SUBJECT: REPLACEMENT OF HCU ISOLATION BOUNDARIES (TSCR NO. 90-01-1),
LIMERICK GENERATING STATION, UNIT 1 (TAC NO. 76960)

SAFETY EVALUATION BY THE OFFICE OF NUCLEAR REACTOR REGULATION

SUPPORTING AMENDMENT NO. 42 TO FACILITY OPERATING LICENSE NO. NPF-39

LIMERICK GENERATING STATION, UNIT 1

FIGURE 1

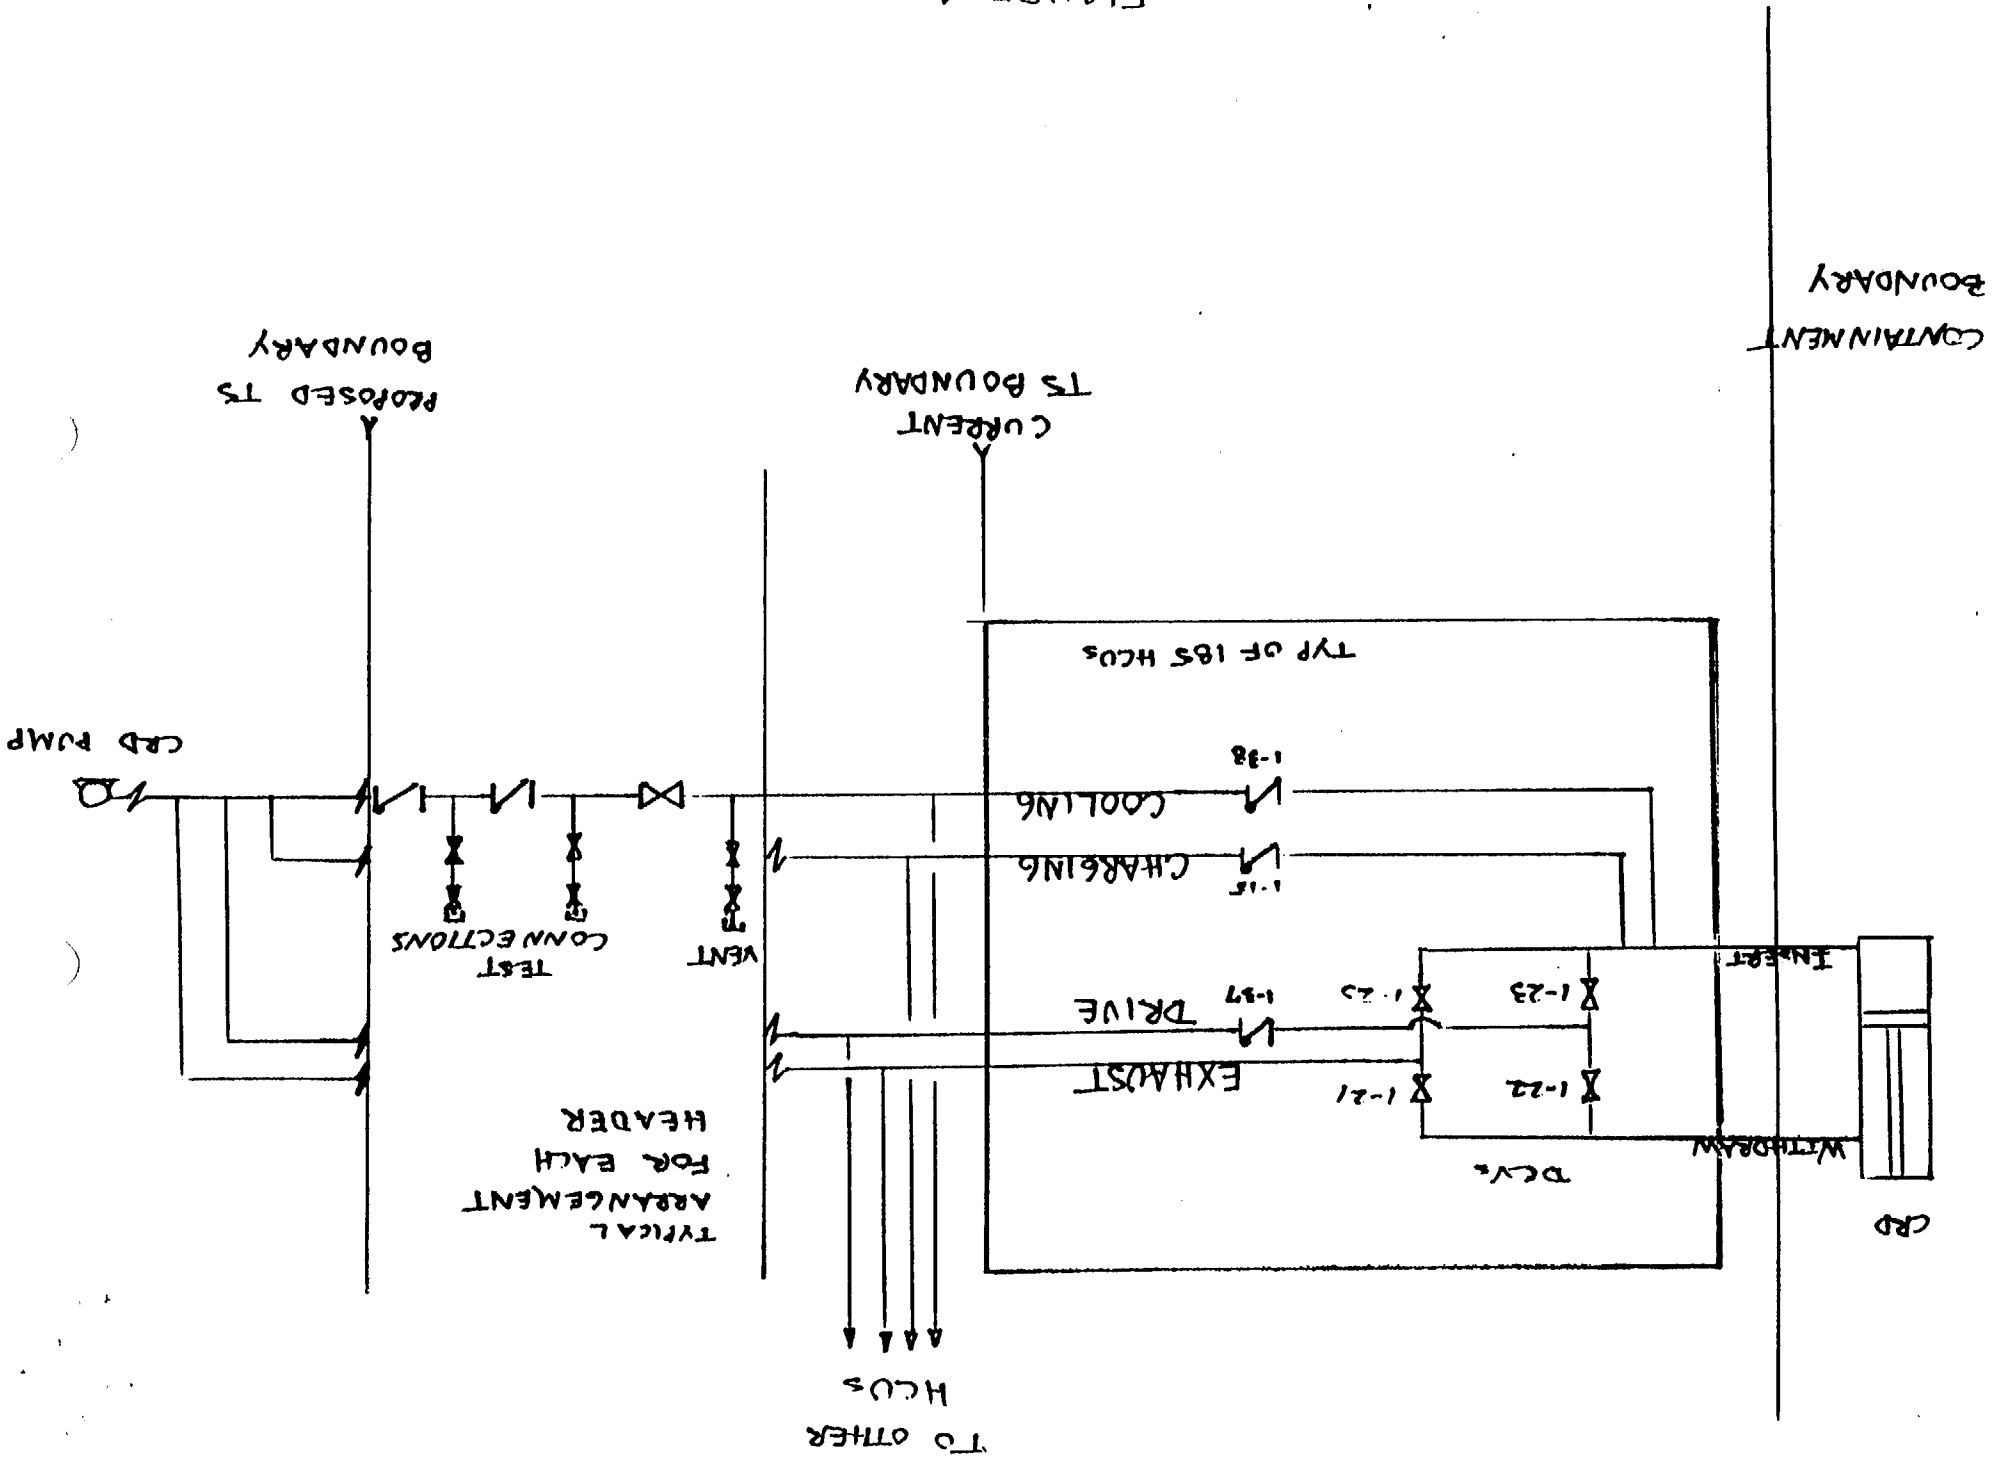
The licensee included a sketch of the proposed arrangement which is enclosed (Figure 1). As shown, the licensee proposes to install two lift check valves, a manually controlled block valve and two test connections on each of the four CRD headers to the HCUs (drive, cooling, charging and exhaust). The general process diagram for the CRD hydraulic system is shown in figure 4.6.7 in the Limerick Final Safety Analysis Report (FSAR) which is also enclosed. The new valves will be installed between the main control station and the existing vent valve shown in Figure 1.

The proposed TS change will take credit for the new valves installed in each of the CRD headers to the HCUs (drive, cooling, charging, exhaust) between the main control station and the vent valve. These valves constitute a new isolation boundary. Each check valve station consists of two check valves, a block valve and two test connections. This enables each check valve to be tested individually instead of during the critical path ILRT. Each check valve station is accessible from an existing platform near the existing vent valves. The change will move the isolation boundary out on the CRD headers.

The staff has evaluated the potential if the lift check valves fail closed, blocking one of the headers. The new check valves will be similar to the present check valves shown in Figure 1 on the cooling, charging and drive headers, but located farther upstream. The licensee plans to "blue" the seats for a polished surface. Experience has demonstrated that unless the lift mechanism is distorted by temperature, becomes severely corroded or is coated by gummy organics in the line, the valve is highly unlikely to fail closed. In any case, even if one of the check valves were to fail closed, it would not affect the ability to scram the reactor.

The staff has reviewed the licensee's analyses and found them satisfactory. The proposed TS changes to relocate the isolation boundary are acceptable.

FIGURE 4.6-8

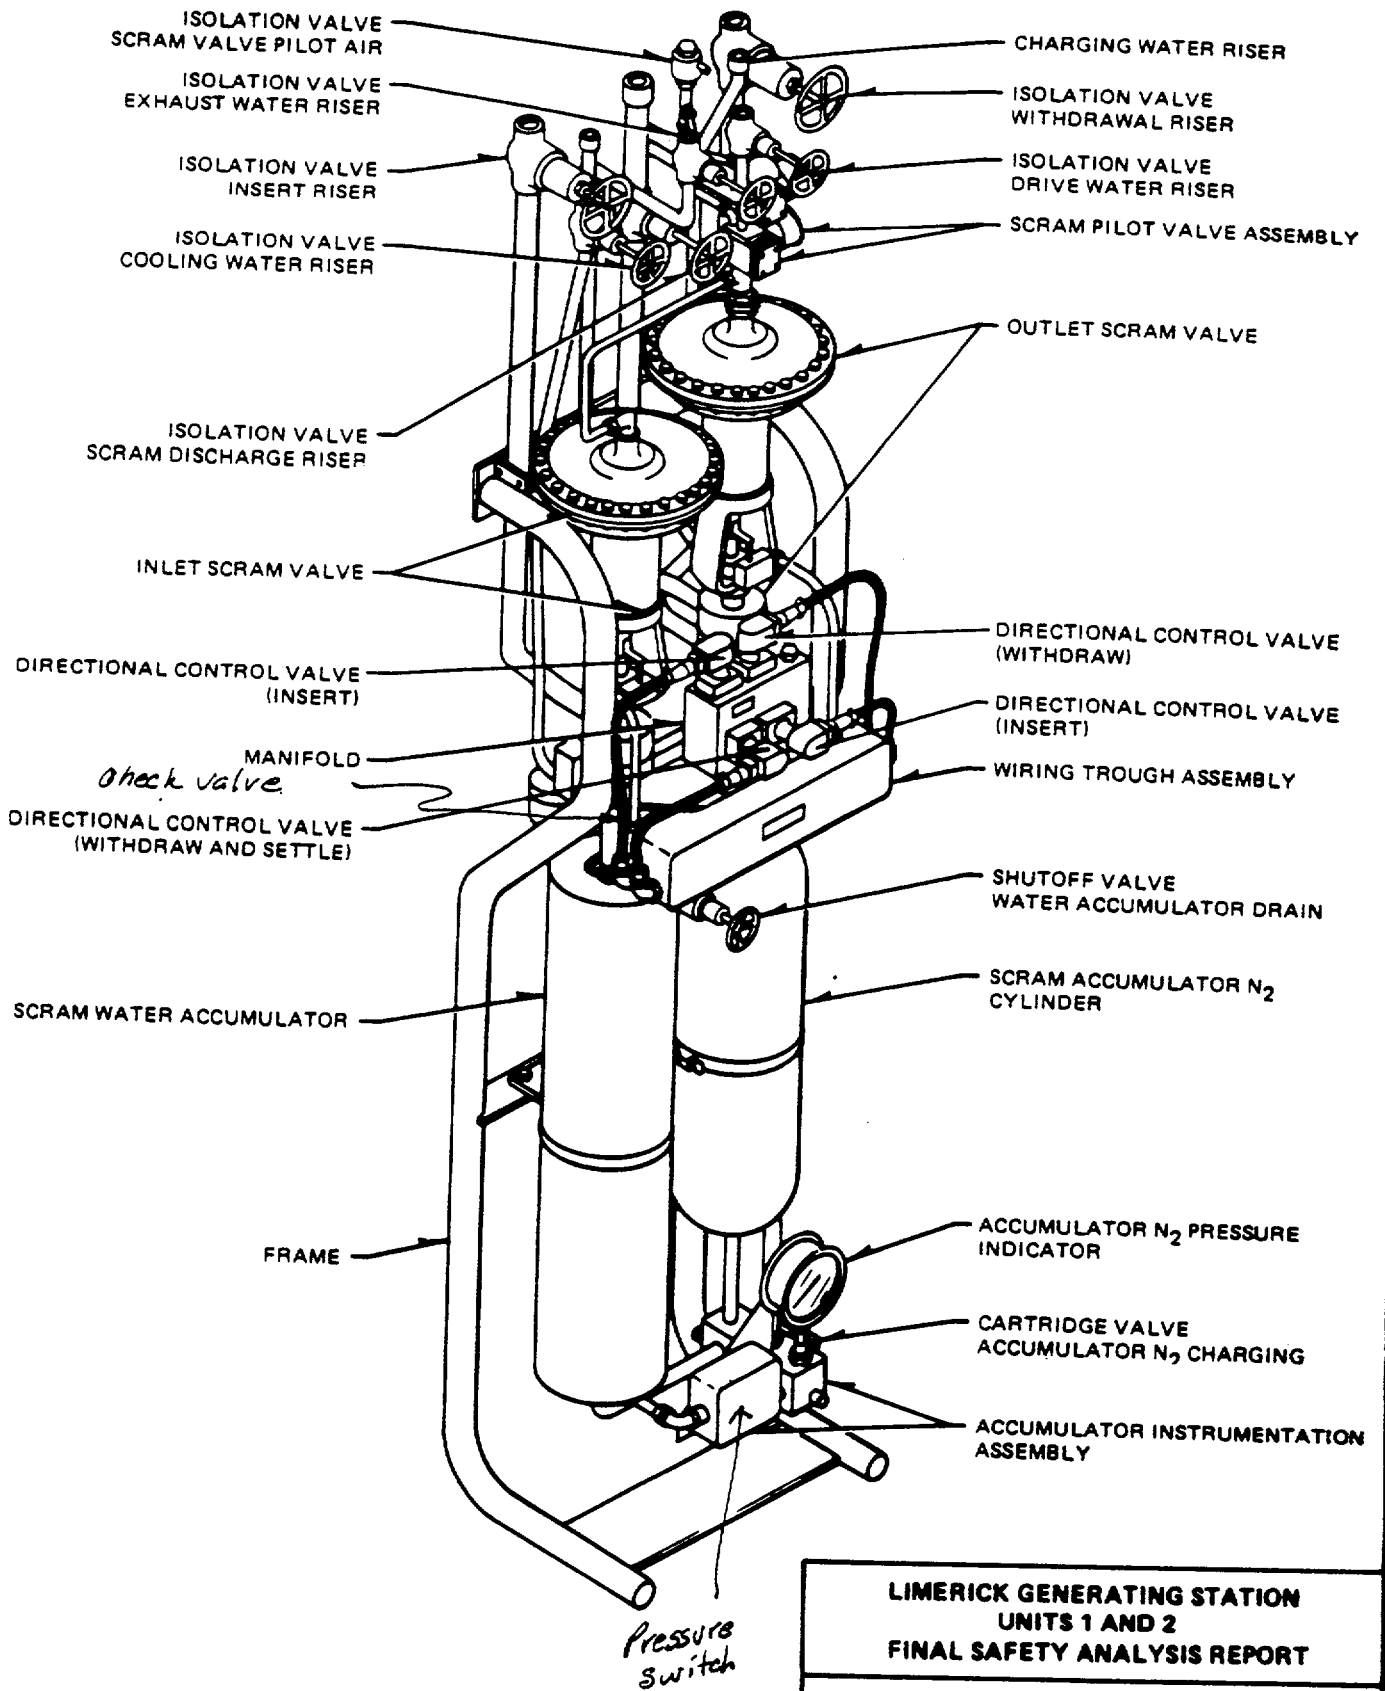
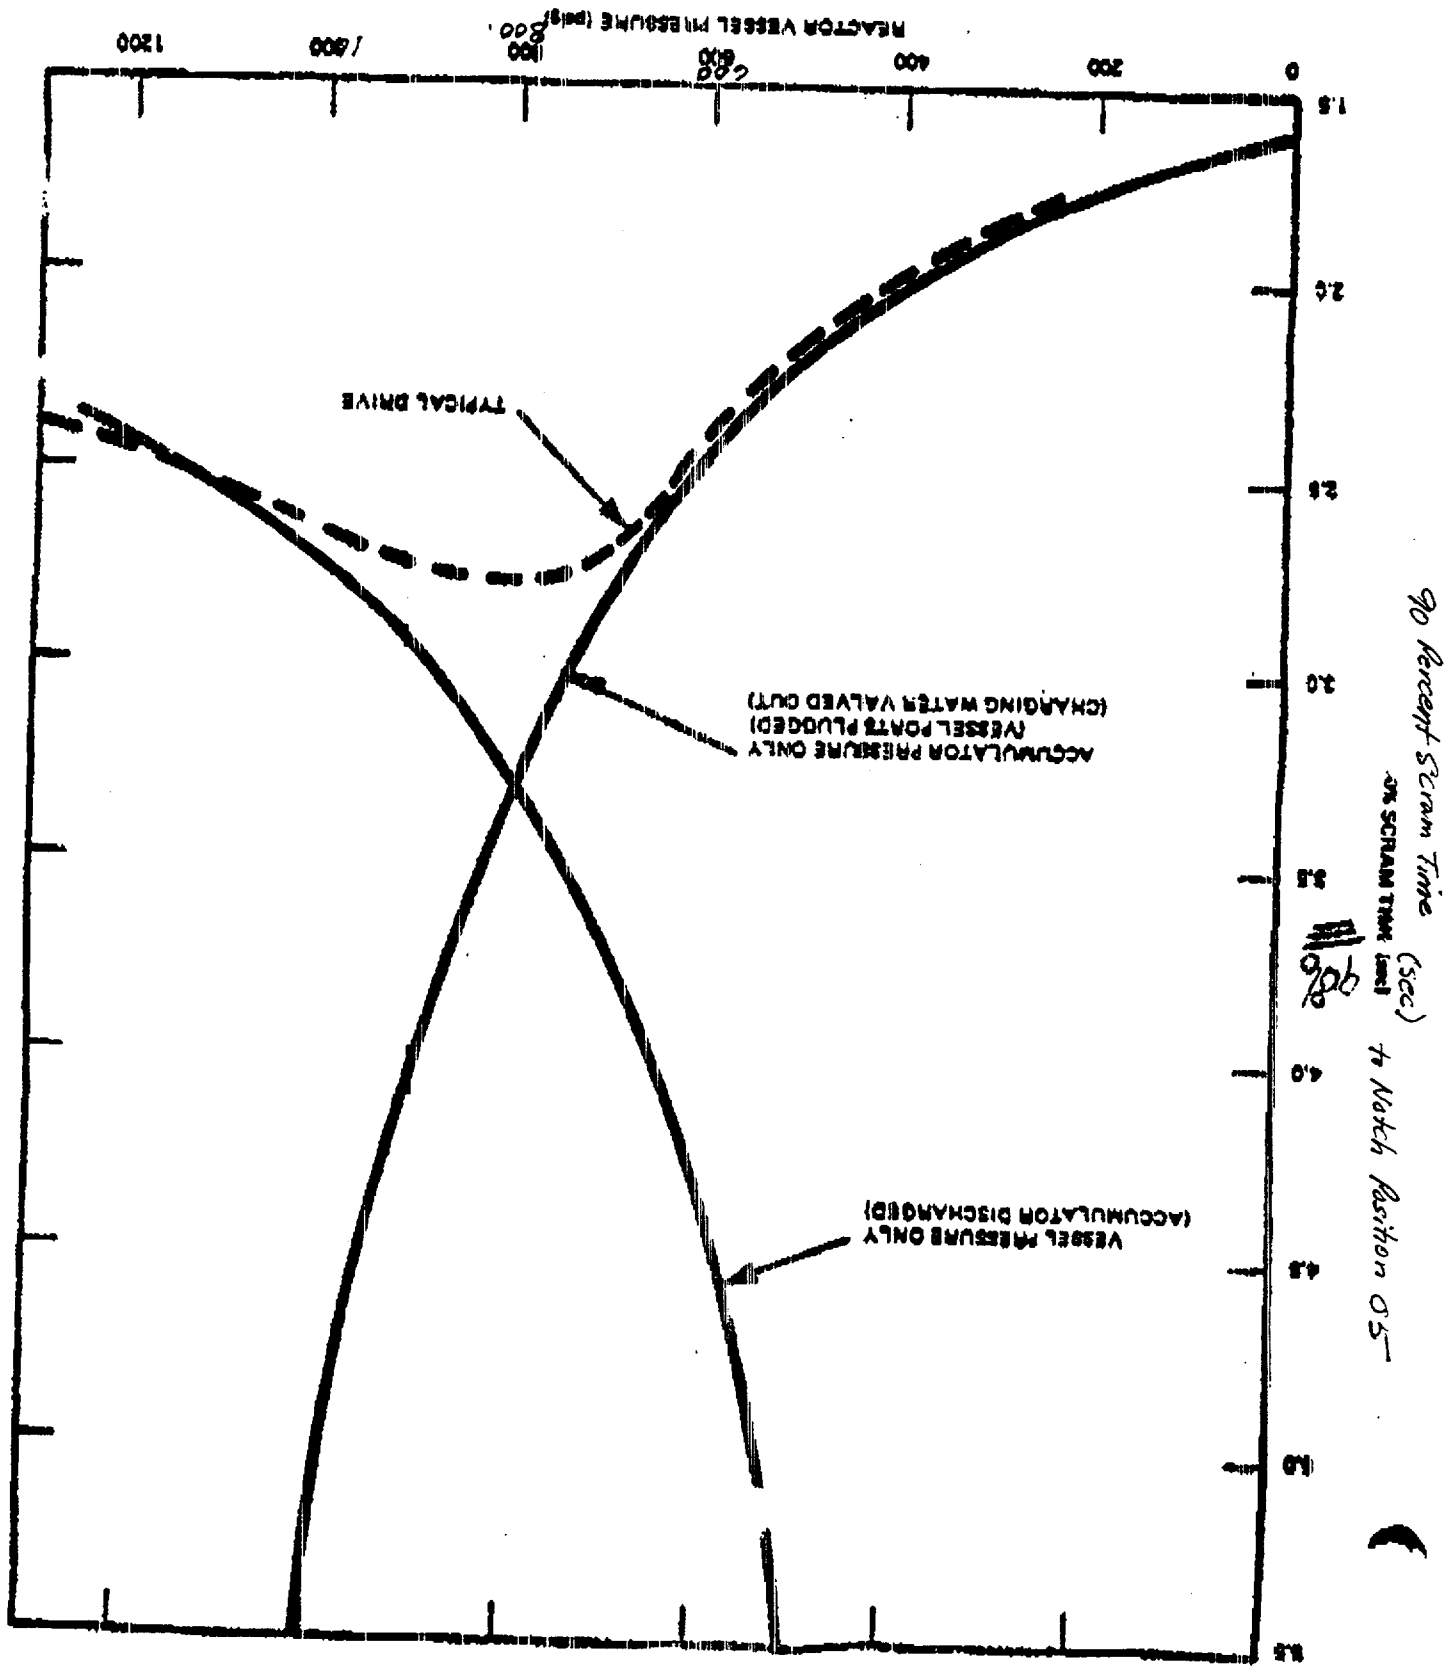
In a BWR 4 such as Limerick, Units 1 and 2, there are 185 control rods, each of which has a HCU. As shown on Figure 4.6.8 in the FSAR (enclosure 3), and in Figure 1, there are 3 check valves and 4 directional control valves on each HCU for a total of 1295 valves. The Integrated Leak Rate Test (ILRT) is a pressurization of primary containment and measurement of total leakage from all isolation boundaries. With the present arrangement, the 1295 valves constitute the isolation boundary. The current method of testing the isolation boundary of the CRD system is to place a bucket under the vent valves shown in Figure 1 and to collect leakage through the HCU at the vent valves on each of the four supply headers during an ILRT. If the total leakage exceeds specified limits, approximately 1300 individual check valves or solenoid valves must be examined to find and repair leak paths. Experience has shown that the total leakage is due to a drop or two of water leakage from many of the ball check valves rather than failure of one or two valves. To avoid these problems, the licensee proposed to relocate the isolation boundary on the headers to and from the HCUs rather than on the HCUs.
